TITLE APPARATUS FOR RESTENOSIS TREATMENT

In re Reissue Application of)
)
 U.S. Patent No. 5,411,466)
)
 Robert L. HESS)
)
 Issued: May 2, 1995)
)
 Serial No.: 08/219,179)
)
 Filed: March 28, 1994)
)
 Title: APPARATUS FOR RESTENOSIS)
 TREATMENT)

TRANSMITTAL LETTER FOR APPLICATION FOR REISSUE OF UNITED STATES UTILITY PATENT

FIG. 1

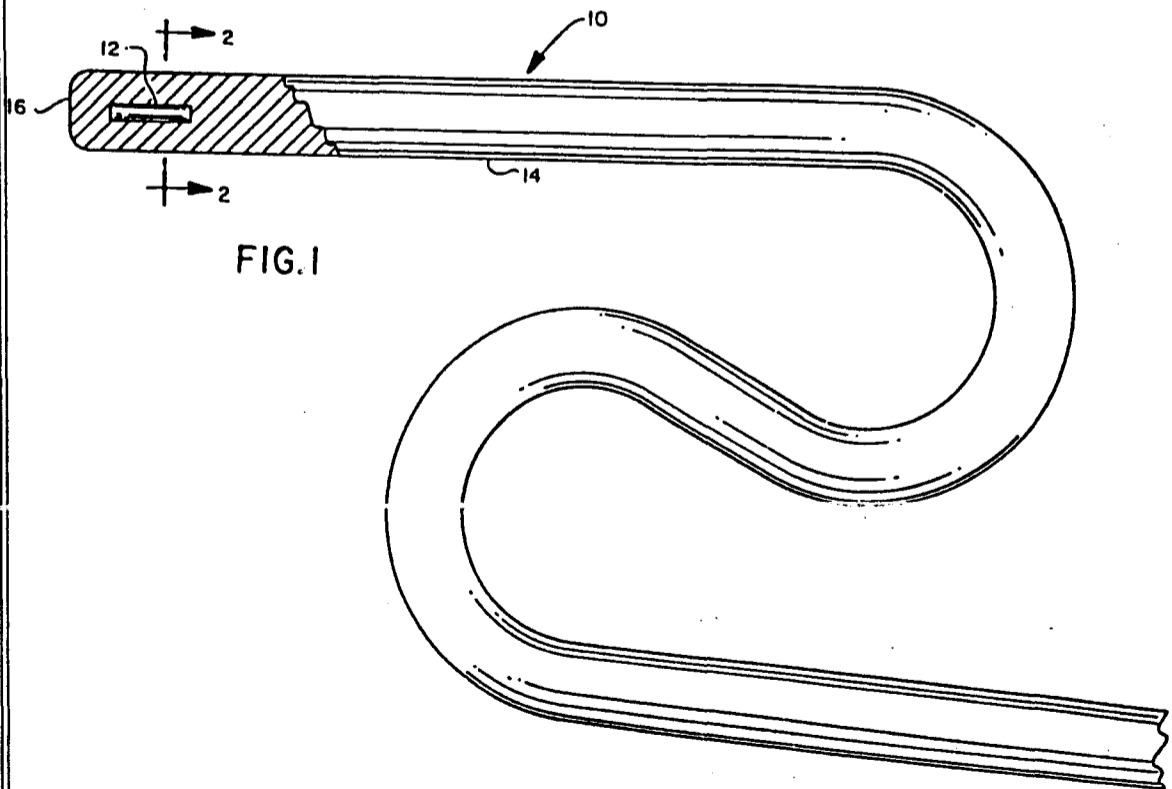
Claims 6-7 and 10-11 stand rejected under 35 U.S.C. § 102 (e) over U.S. Patent No. 5,084,002 by *Liprie* (hereinafter "*Liprie*"). The Office Action states that the above-identified claims were clearly anticipated by *Liprie*.

It is respectfully submitted that amended independent Claims 6 and 10 are neither disclosed nor suggested by *Liprie*. Referring to FIG. 1 of *Liprie*, below, a partial cross-sectional view is shown of a relatively pure iridium core member or seed 12 form in the end of the unitary elongate relatively pure platinum delivery wire 14. See col. 4, lines 18-21 and FIG. 1, below. Thus, the device and the dose means of *Liprie* are fixedly positioned together.

In regard to amended Claim 6, *Liprie* fails to teach or suggest, *inter alia*, the newly recited positioning means operatively connected to said device for advancing said device and dose means within the stenosed region of an artery that has been reduced by angioplasty or other procedure, said positioning means also being operatively connected to said device and dose means for positioning the device and dose means between a first position and a second position, wherein the first position the dose means is positioned within the stenosed region of the artery in a non-deployed configuration and a second position, wherein the dose means is in a deployed configuration for treating at least a portion of the stenosed region of the artery. When positioned, this configuration is used to move from a non-deployed configuration to a deployed treatment configuration in which the patient is being actively exposed to the radiation.

FIG. 1

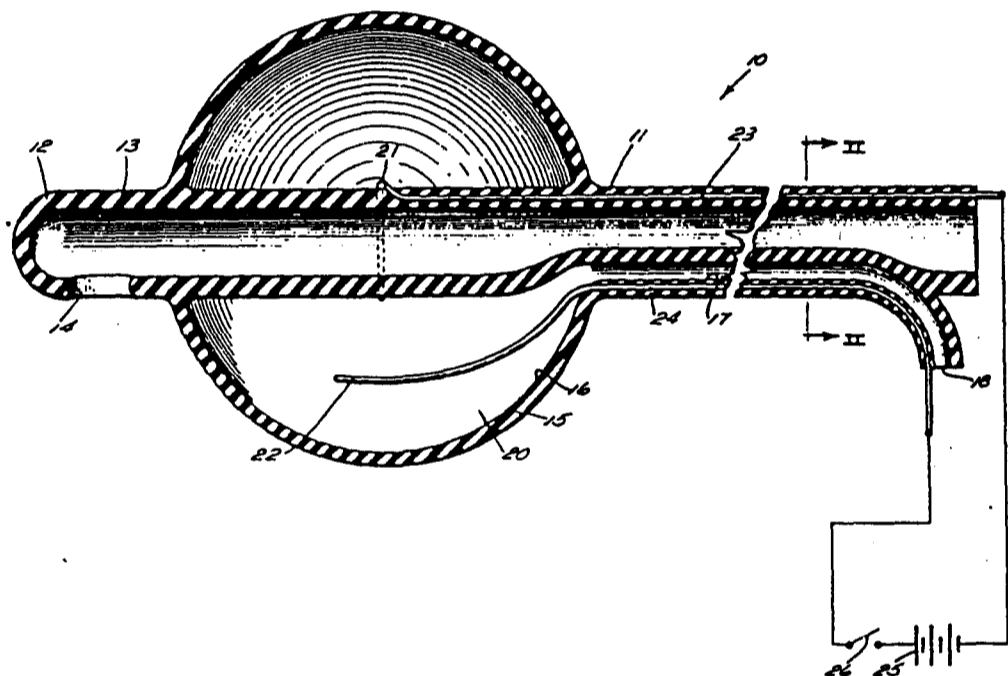
Liprie discloses the claimed device except for the specific use of the radioactive dose in a liquid or gaseous form. Zoumboulis teaches that it is well known to use a radioactive substance in a form other than solid, i.e. liquid. Therefore a modification of Liprie such that the radioactive dose is in any well known and conventionally used form would have been obvious to one skilled in the art.

In contrast, *Liprie* teaches a source 10 that includes a relatively pure iridium core member or seed 12 formed in the end of a unitary elongated pure platinum delivery wire 14. See col. 4, lines 16-21 and FIG. 1, above. *Zouboulis* discloses the use of electrodes in combination

with this solution containing a radioactive isotope that is particularly advantageous in that ions are formed in the solution and migrate to one of the electrodes in accordance with laws of iontophoresis to accumulate a solid radioactive source. See col.1, lines 20-48 and FIG. 1, below.

Thus, neither *Liprie* nor *Zoumboulis* teach or suggest, *inter alia*, positioning means operatively connected to said device that is movable when positioned between a first non-deployed configuration and a second deployed configuration. Further, neither *Liprie* nor *Zoumboulis* teach or suggest, *inter alia*, an arrangement where a catheter is adapted to at least partially reposition relative to the radiation source for treatment. Accordingly, withdrawal of this rejection is respectfully requested.
